Murrieta Valley Unified School District
41870 McAlby Court
Murrieta, CA 92562

DISTRICT BID ADDENDUM NO. 2

Re: 2025-26-02 New Staff and Student Bathroom Project

Addendum 2 - Fire Alarm Sites - 11/12/25

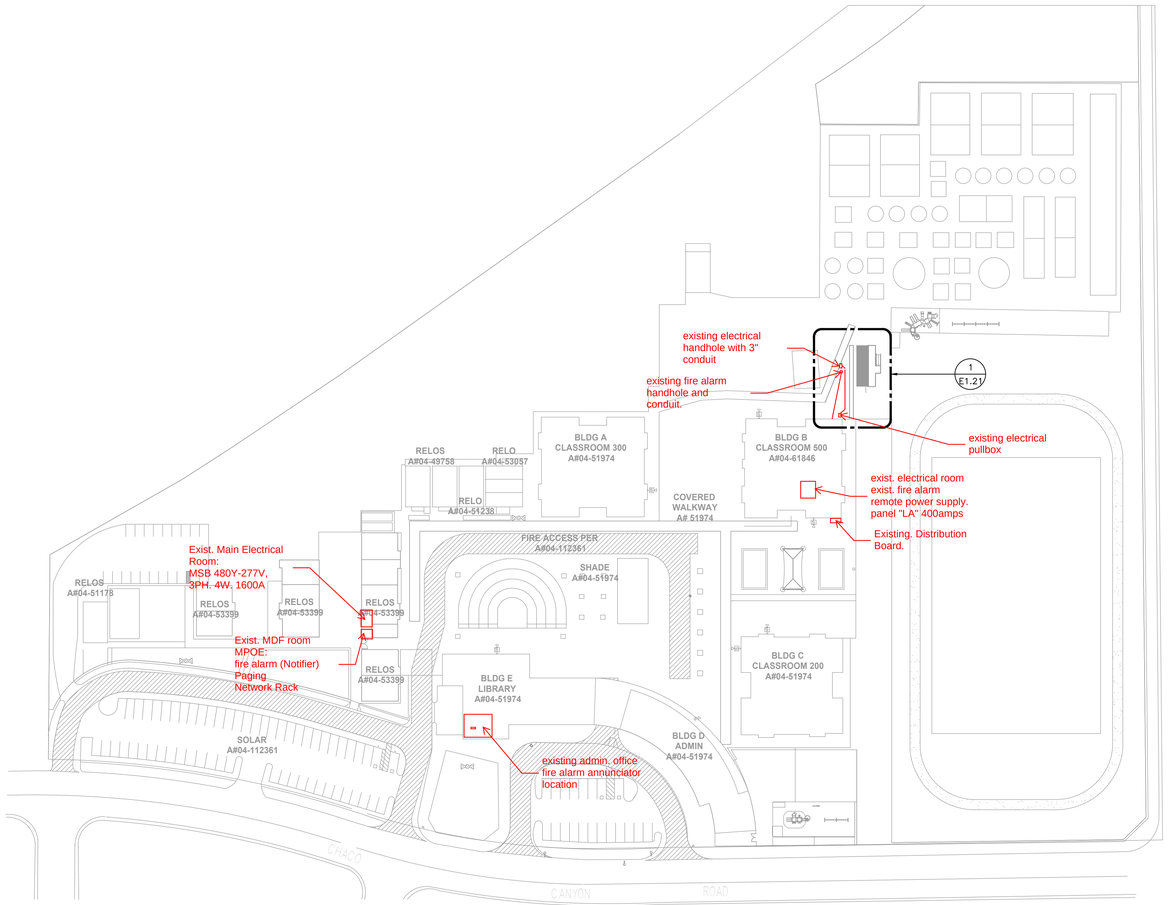
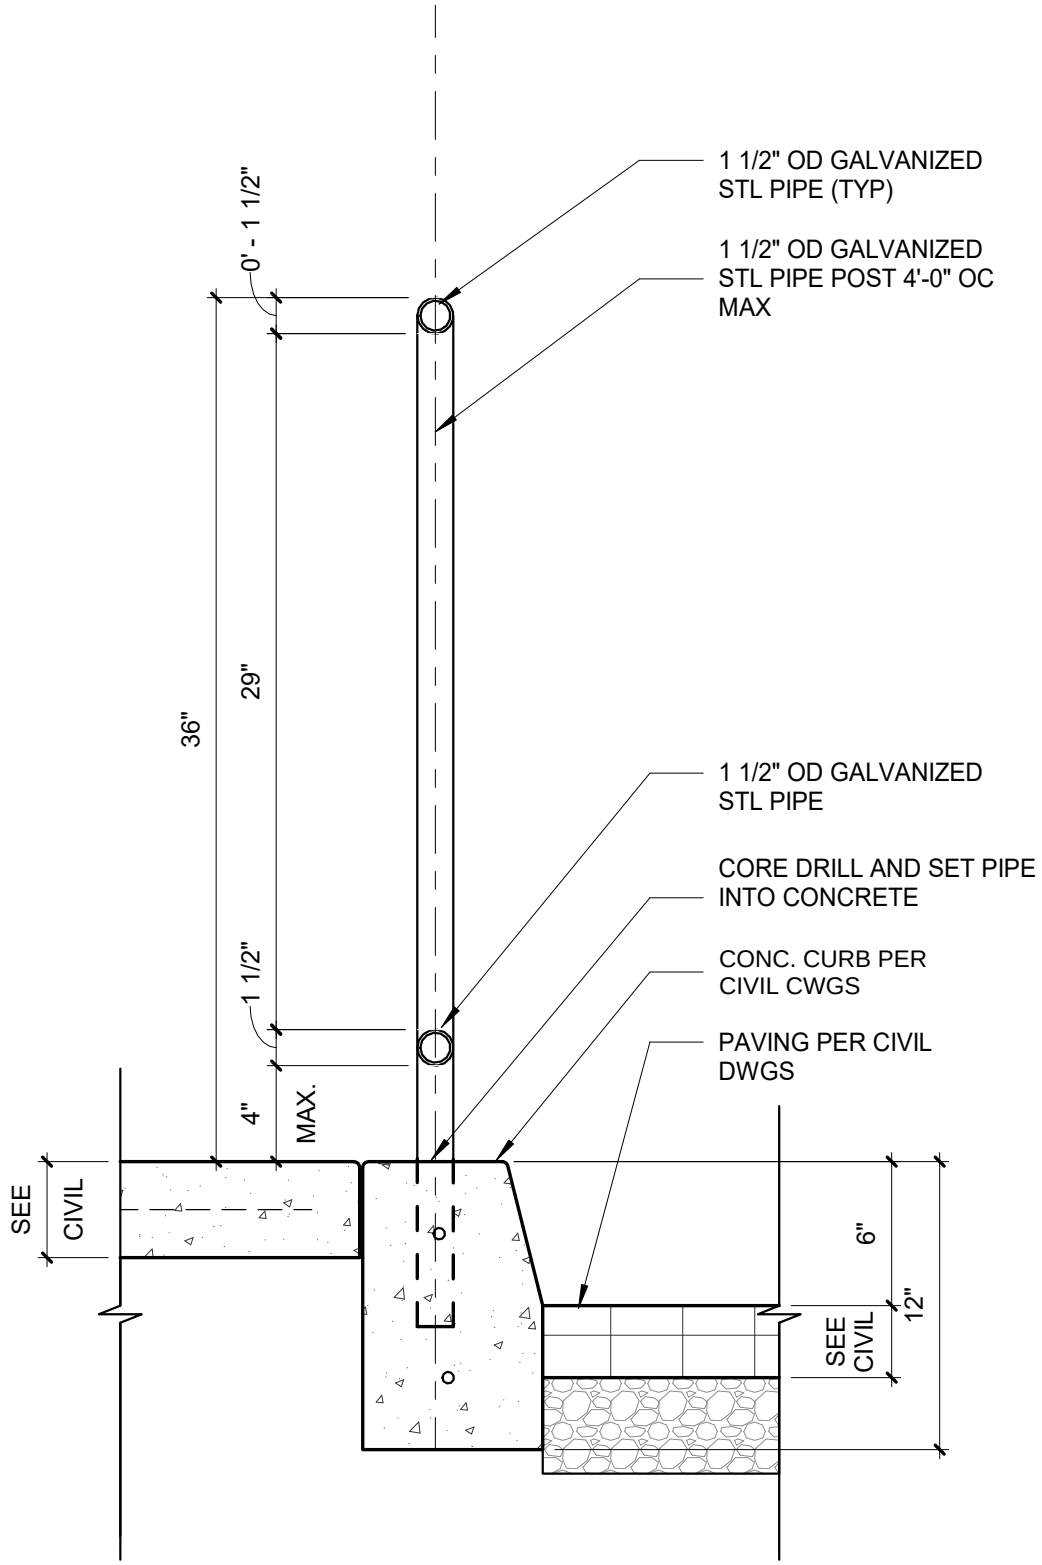
23. Per KN 1&2/FA1.11, it stated, "Provide New Conductors within existing 1" underground conduit" for (N) Fire Alarm wires. From the Site Survey during the job walk, there was no (E) Pull Box for the underground FA conduit at the nearby (N) Portable Building area as shown on the Plan (or maybe I missed). Do we need to Saw-Cut & Trench for extending (N) FA conduits from the (E) pull box to the Portable Building? Or, can (N) extend conduit above the ground? Please locate & indicate where the (E) FA Pull Box at the site on the Plan FA1.11 with more detailed information including the distance from (E) pull box to the portable building.

Answer: Attached is a markup identifying an existing fire alarm pull box from the design team's initial site investigation. Saw cutting and trench may be needed to extend existing routing to restroom building.

PIPE GUARDRAIL AT CONCRETE CURB

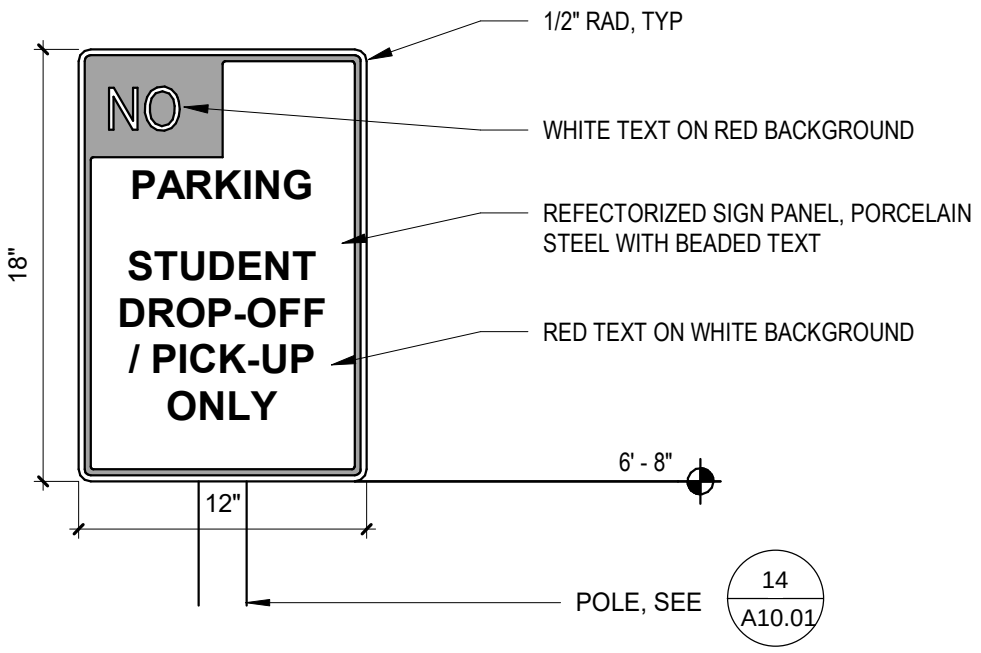
28. KN 5.82/A1.22 & KN 5.84/A1.23 Required Metal Railing and (N) Concrete Curb; however, there were no details in the plans. Please provide (N) Railing and Curb detailed plans with its pipe size, height & length, railing footing size in elevation view.

Answer: Architectural detail of railing attached, refer to detail 1. Also, revise accessible drop-off signage (per approved 9/A 10.01) to the attached detail 2, adding the "no parking" verbiage.
